**Response to Comments for the Chemical Waste
Management Bakersfield
Draft Post-Closure Permit Renewal**

CAT000624056
27001 Round Mountain Road
Bakersfield, CA 93308

The following provides the Department of Toxic Substances Control (DTSC) response to comments for the Chemical Waste Management (CWM) Bakersfield Draft Post-Closure Permit Renewal (PCPR). The public comment period for this PCPR ended August 31, 2006. All comments received for this PCPR were submitted by CWM. CWM submitted comments on each of the three documents in the public repository which included a Fact Sheet, the Draft Post-Closure Permit, and the Post-Closure Care Findings and Determination document.

Figure 1. Total Dissolved Solids in Impacted Wells (CW10, MW1, MW06) and Background Well (CW17)

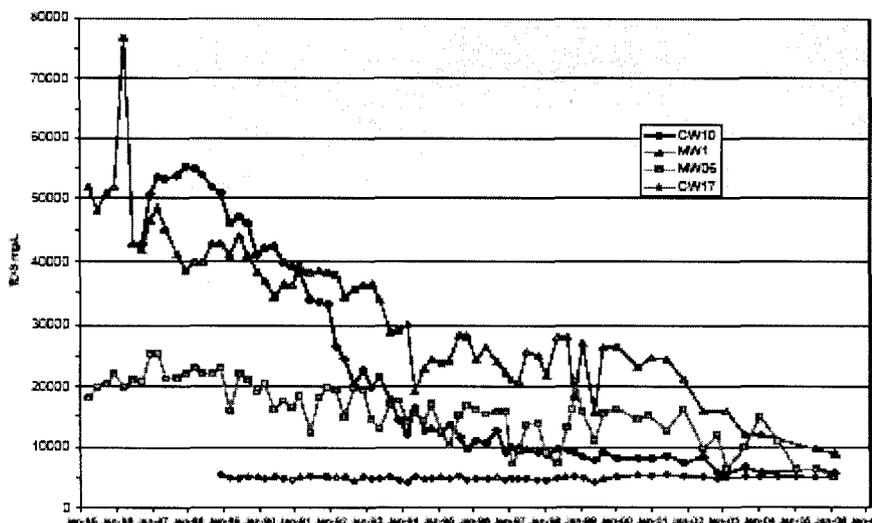
The evidence cited in the Draft Permit for the finding includes *"document review, analysis, and field observations which show that the existing closure cover is not effective in preventing rainfall from entering the waste or sustaining damage from weathering and animal activity."* However, extensive data collected over the past 19 years show that the cover is effective in preventing rainfall from entering the waste and from sustaining damage from weathering. The period from 1991 through 1998 contained 7 years of above average precipitation (based on data from the Bakersfield Airport station, where the average precipitation is 6.18 inches), including the highest (13.32 inches, 1998) and sixth highest (9.84 inches, 1995) annual precipitation for the period of record (69 years). Yet, no new impacts were recorded in the EWMU or WWMU detection monitoring program

wells. Further, these heavy rain years had no discernable effect on the historical declining concentration trends of waste constituents in impacted groundwater (see Figure 1, below). Therefore, the wastes appear to be *isolated* from environmental receptors by the site geology and closure activities and no increased “*risk posed by these wastes*” has manifested in the 19 years since the closure cover was completed, regardless of precipitation patterns.

The groundwater monitoring results to date indicate that no releases have occurred to the groundwater from the EWMU and no new releases have occurred to the groundwater from the WWMU (Geomatrix, 2006b). In fact, the impacts to groundwater from the initial release from the WWMU, that occurred prior to closure, have been attenuating with time (Geomatrix, 2006b), indicating that the closure activities have been effective in isolating the remaining waste in the WWMU. DTSC apparently came to a similar conclusion in their *Comprehensive Monitoring Evaluation (CME) Report for the Chemical Waste Management, Inc. Bakersfield Facility* dated September 3, 2002 (DTSC, 2002b).

The DTSC Draft Post-Closure Permit Special Conditions have been modified to allow for the following:

1. Within 60 days of the effective date of the permit, submit a waste declassification notification pursuant to California Code of Regulations, title 22, section 66260.200; or
2. Within 60 days of the effective date of the permit, submit a work plan demonstrating the Facility will meet the closure by removal and decontamination standards of chapter 14 of division 4.5 of the California Code of Regulations, title 22; or
3. CWM shall follow the Special Conditions of the Draft Post-Closure Permit, which are included in Part V, 3. of the Final Post-Closure Permit.

Figure 1. Total Dissolved Solids in Impacted Wells (CW10, MW1, MW06) and Background Well (CW17)

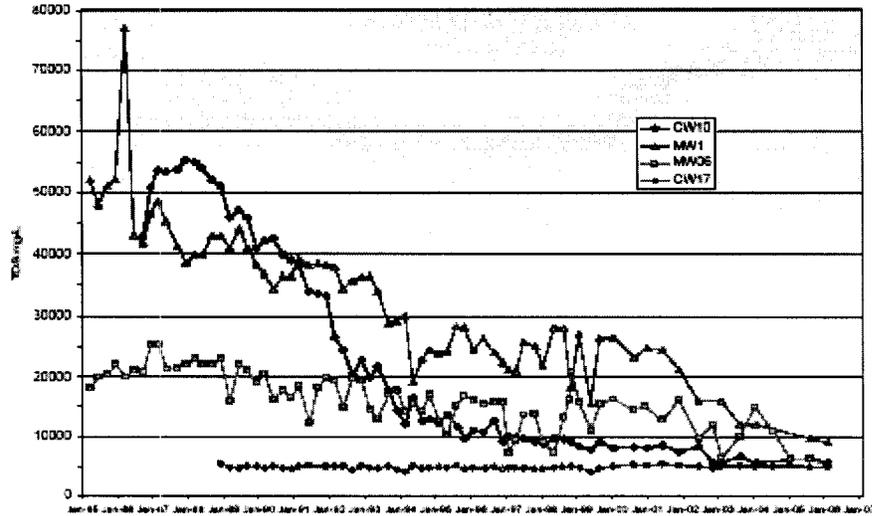
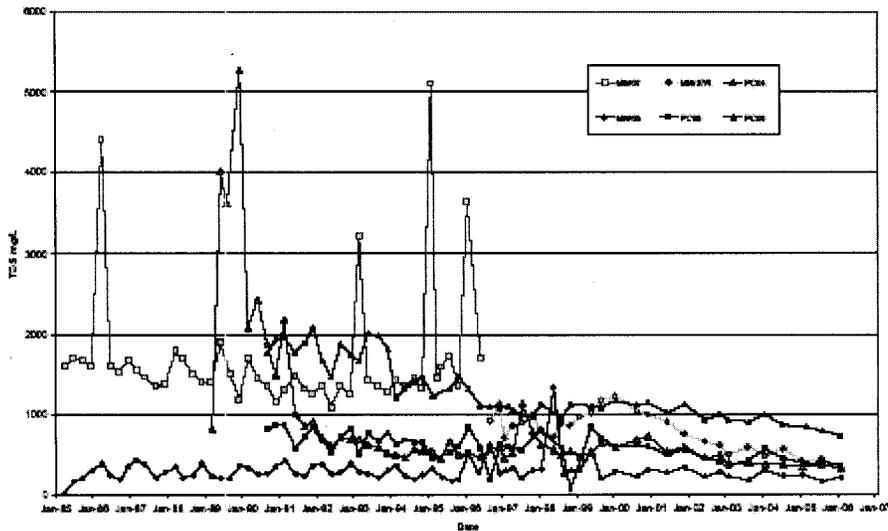
2.1.3 Local Water Quality. The Bakersfield Facility is located in an area of relatively high background levels of TDS. In 1985, a release of inorganic constituents comprising sodium, sulfate, and TDS, which was identified as primarily scrubber waste, was discovered in groundwater at the northern and southern margins of the Western Waste Management Unit (WWMU). The release was attributed to the infiltration of scrubber wastes from permitted, unlined disposal ponds along the northern ridge and from wet-weather ponds along the southern portion of the site. The release likely occurred prior to 1980, as those ponds were not used by CWM. The five monitoring wells that showed groundwater impacts from the initial release documented in 1985 (wells CW10, MW1, MW06, and CW17) have all seen significant improvement in water quality during the period of record, which ranges from 17 to 21 years (See Figures 1 and 2). DTSC's own technical experts reached similar conclusions in the CME.

orders of magnitude reduction in concentrations of the impacting constituents, which comprise inorganic chemicals, primarily sodium and sulfate (Figure 1). **None of these wells, even during the initial stages of monitoring in 1985, contained hazardous concentrations of waste constituents.** This 18-year post closure period included 9 years of aboveaverage rainfall, 7 of the top 20 annual rainfall years, and the highest annual rainfall year for the 69-year period of record at the Bakersfield Airport station (located about 9 miles southwest of Facility). Therefore, the 18-year period since closure provides a reliable test of the Bakersfield Facility's ability to perform for the 30-year required post-closure care period.

Please see DTSC Response to Comment 30).
